# ADDENDUM TO MC68341 Integrated Processor User's Manual

#### April 19, 1995

This addendum to the initial release of the MC68341UM/AD User's Manual provides corrections to the original text, plus additional information not included in the original. This document and other information on this product is maintained on the AESOP BBS, which can be reached at (800)843-3451 (from the US and Canada) or (512)891-3650. Configure modem for up to 14.4Kbaud, 8 bits, 1 stop bit, and no parity. Terminal software should support VT100 emulation. Internet access is provided by telneting to pirs.aus.sps.mot.com [129.38.233.1] or through the World Wide Web at http://pirs.aus.sps.mot.com.

Figure 3-12. M68300 Write Cycle timing

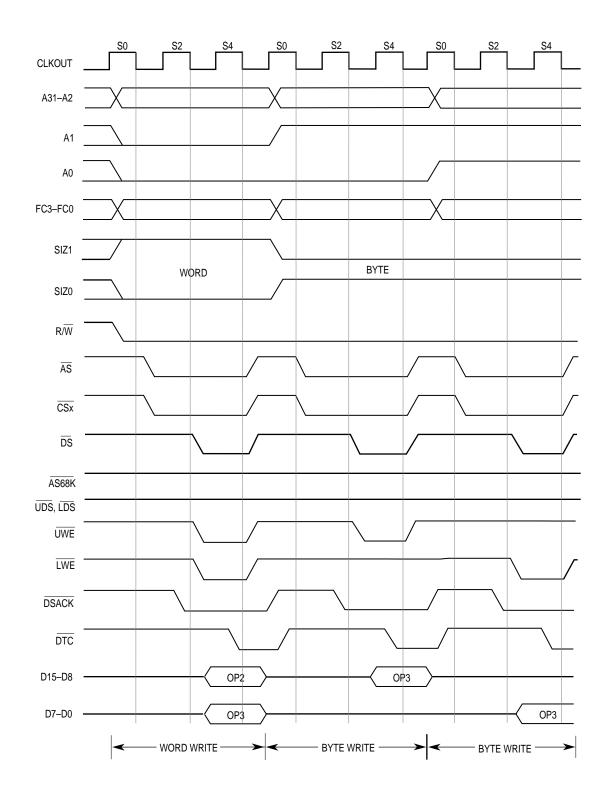
On page 3-25, the M68300 write cycle timing diagram (Figure 3-12) shows incorrect timing for  $\overline{DS}$ ,  $\overline{UWE}$ , and  $\overline{LWE}$ . On page 3-28, the M68000 write cycle timing diagram (Figure 3-14) shows incorrect timing for  $\overline{AS68K}$ ,  $\overline{CSx}$ ,  $\overline{UDS}/\overline{LDS}$ , and  $\overline{UWE}/\overline{LWE}$ . Replace these figures with the following corrected figures.

Figure 11-14. Circuit For Interfacing 8-Bit Device to 16-Bit Memory in Single-Address DMA Mode

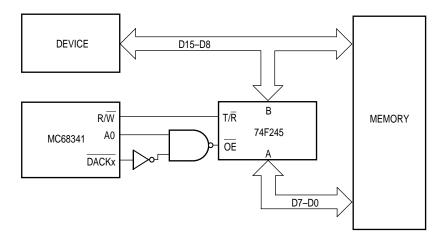
On page 11-10, the logic driving  $\overline{OE}$  on the 74F245 in Figure 11-14 should be corrected as shown below. Although not detailed, the byte enables for the memory block should be controlled during reads to prevent contention between the upper and lower bytes of the data bus when D7-D0 is muxed to the upper data byte.

Case 864A-03

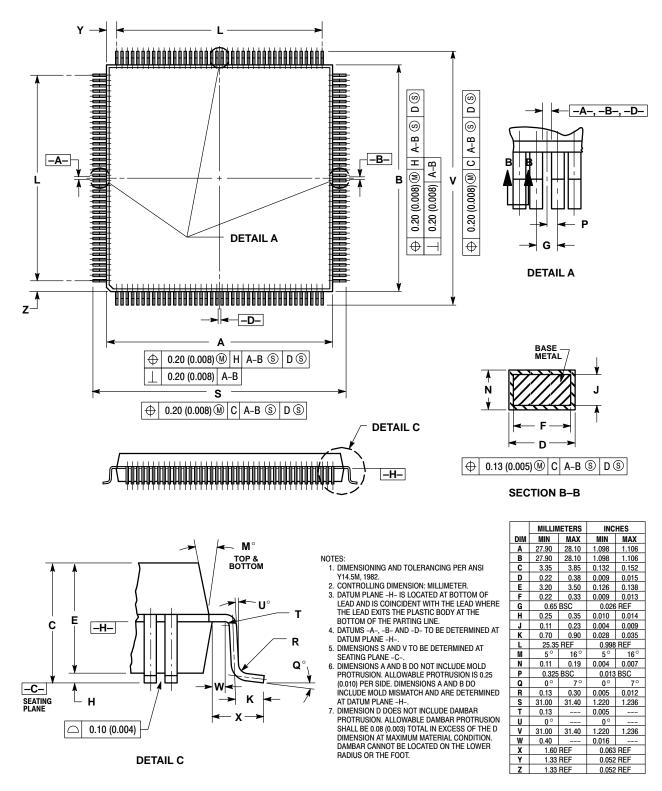
The package dimension drawing on page 13-3 should be discarded and replaced with the following drawing.
